Ordinary Meeting of Council

Item 9.1	Development Application DA.2021.1153 - 59 Lot Torrens Title Business and Industrial Subdivision with Two Residual Lots - 360A Lanyon Drive, Tralee	
	<i>Attachment 1</i>	<i>DA.2021.1153 - 4.15 Assessment Report - 360A Lanyon Drive, Tralee2</i>
	<i>Attachment 2</i>	<i>DA.2021.1153 - Plans - 360A Lanyon Drive, Tralee..... 41</i>
	<i>Attachment 3</i>	<i>DA.2021.1153 - Submissions - 360A Lanyon Drive, Tralee..... 49</i>
	<i>Attachment 4</i>	<i>DA.2021.1153 - Draft Conditions - 360A Lanyon Drive, Tralee 60</i>

ITEM 9.1 DEVELOPMENT APPLICATION DA.2021.1153 - 59 LOT
TORRENS TITLE BUSINESS AND INDUSTRIAL
SUBDIVISION WITH TWO RESIDUAL LOTS - 360A
LANYON DRIVE, TRALEE

ATTACHMENT 1 DA.2021.1153 - 4.15 ASSESSMENT REPORT - 360A LANYON
DRIVE, TRALEE

Figure 7 & 8: 1.8m visual wall proposed along the rear boundaries of the lots adjoining Envirova Drive. (Prepared by spire)

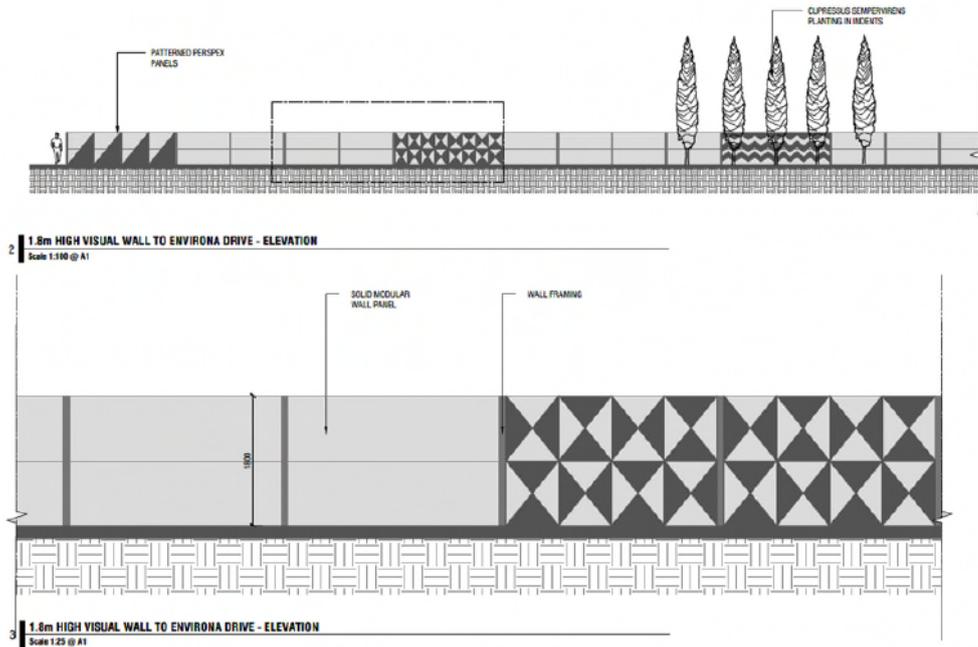
Concern was raised as to the visual wall to be constructed along the south eastern boundary of the site and that the plans did not indicate the exact location and that landscaping may be carried out outside of the property boundaries. Further concern was raised as to who will maintain the landscaping and that stock proof be placed along the boundary to ensure landscaping is not damaged by stock on adjoining properties.

Concern was raised that a major stormwater path and that the visual wall will impact sheet flow and direct the flow along the toe of the wall.

Comment: The consent will contain a condition that all walls and retaining walls are to be located wholly within the subject lot. The applicant has also provided detail that landscaping is to be provided along the interface of the B7 lands and Jerrabomberra Creek and that no stock proof fencing is warranted along the boundary due to the introduction of the visual wall.

Comment: Council's Development Engineer has assessed stormwater requirements and offered no objections subject to recommended conditions of consent.

Figure 3: Extract from exhibited Design Report

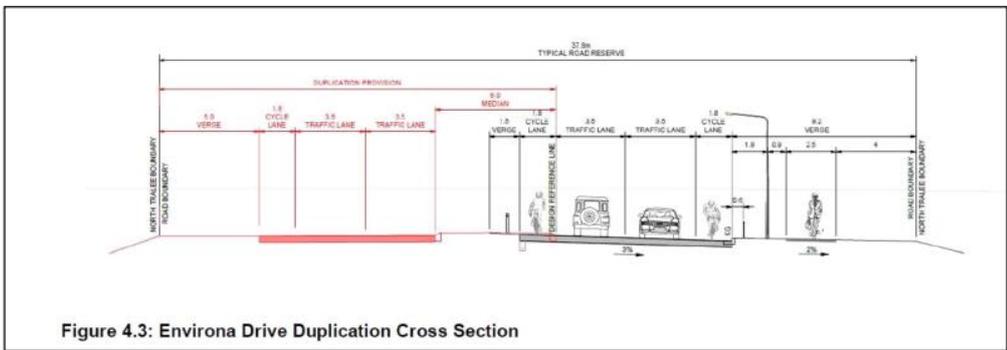
The exhibited Design Report with the Development Application indicates a road reserve width of 37.8 metres, however, the width as presented in the exhibited plan of subdivision varies between 37 metres and 38.5 metres – see Figure 2. In reviewing the Design Report, there are significant inconsistencies with the width of the proposed verge. Environa Drive, as a higher class road, would have numerous services, a footpath, trees and streetlights is shown in the plans as only having a 5 metre verge – see Figure 3.

It is recommended that the width of Envirova Drive road reserve within the proposed subdivision be increased to 40.3 metres consistent with the width of the northern section of the road within Poplars (Northern Entry Road).

Figure 5: Latest Intersection arrangement – Environa Road

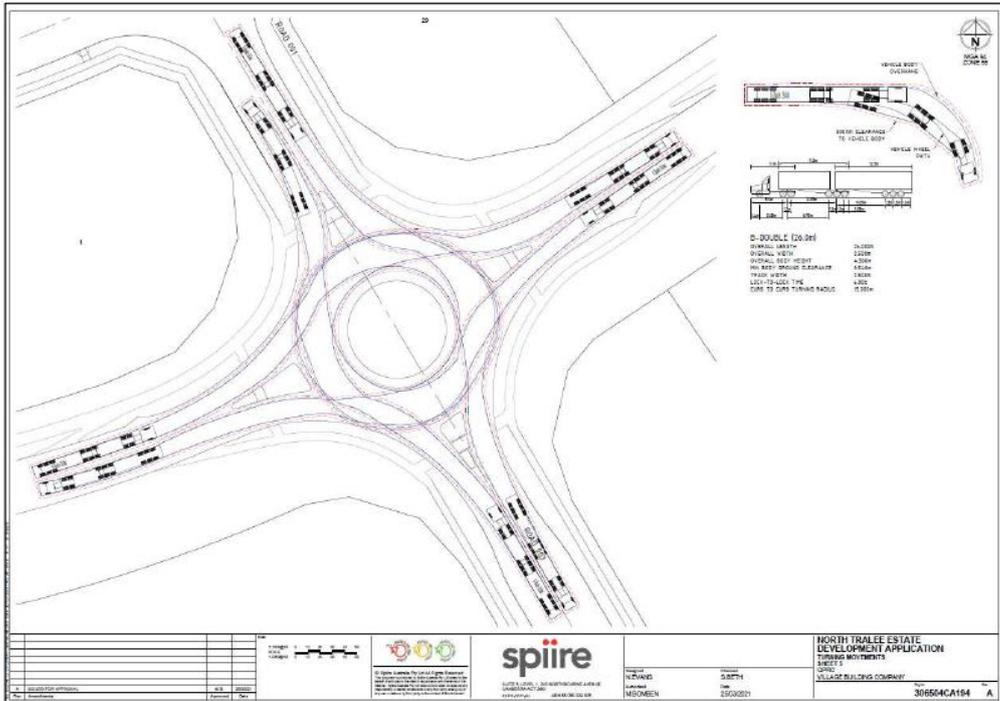
The exhibited plans do not accurately show how the lot alignment will sufficiently allow for the future duplication of Environa Drive. Additionally, the details are not clear on the allowance for the future intersection noting that the proposed roundabout will need to be sufficient in size to accommodate the required duplication of Environa Drive. The subdivision does not appear to provide for the size of the proposed roundabout that will be required.

It is recommended that the size of the intersection reserve within the proposed subdivision be determined and accurately presented prior to determination.

Figure 7: Exhibited Cross Section of Visual Wall – Bushfire Assessment

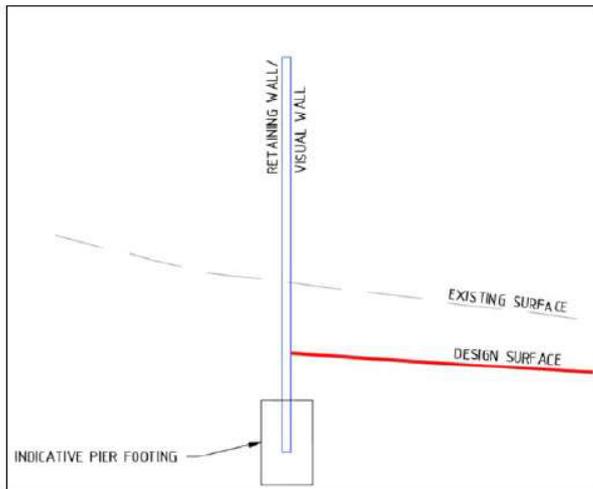
By reference to the exhibited cross section in Figure 7, the following concerns are also raised:

- The property boundary is not identified on the section and accordingly there is no indication of whether or not this impacts directly on our client's land.
- The cross section appears to suggest that the visual wall will be partly excavated below the existing ground level on our client's land. Accordingly, no detail are provided as to how a visual wall would impact on existing drainage patterns (overland flow).
- There is no scale on the cross section provided, and reference is made in the bushfire assessment that the height of the wall will be 3 metres. However, it is unclear whether the 3 metres referred to is the height of the wall above ground or the total height from the pier footing.
- A hard wall is not compliant under the DCP as the native vegetation transition has not been allocated sufficient space within the boundary subject to this development application.

Figure 10: Adopted Neighbourhood Structure Plan for North Tralee

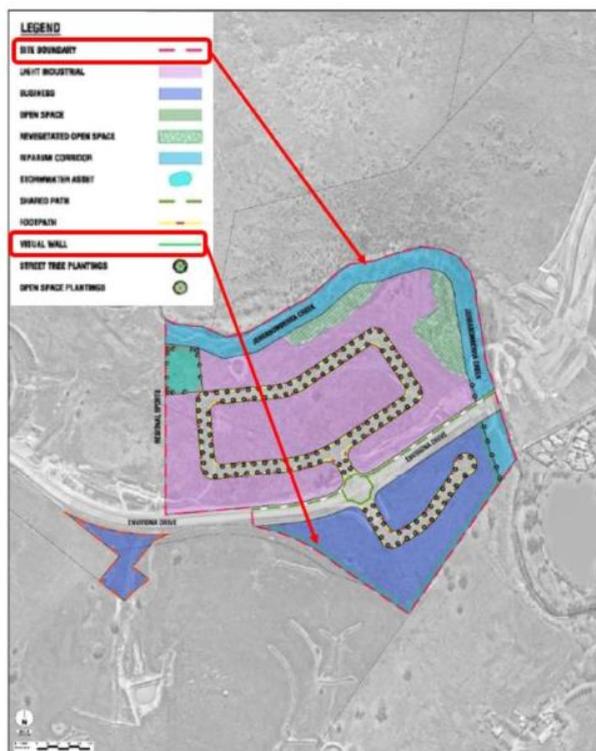
The frontage to Environa Drive is a critical street address that has not been appropriately considered in the development application. The DCP notes that the interface between new development, rural lands, environmental conservation zones and areas of high biodiversity value should consider appropriate transitions and design solutions which minimise any adverse impacts from development on these areas. The proposed subdivision does not address the frontage of the lots north and south of Environa Drive. These lots have access/driveways from internal new roads with the rear of the lots facing Environa Drive. A landscape plan including indicative cross sections should be provided that illustrates the type of planting at maturity; the extent of any mounding and the type of screen wall proposed. By way of an initial comment, a painted timber paling fence is not considered appropriate.

We recommend an appropriate design solution that provides for a high quality landscape and solid screen be prepared including indicative cross sections and that our client be renotified prior to the Development Application being determined.
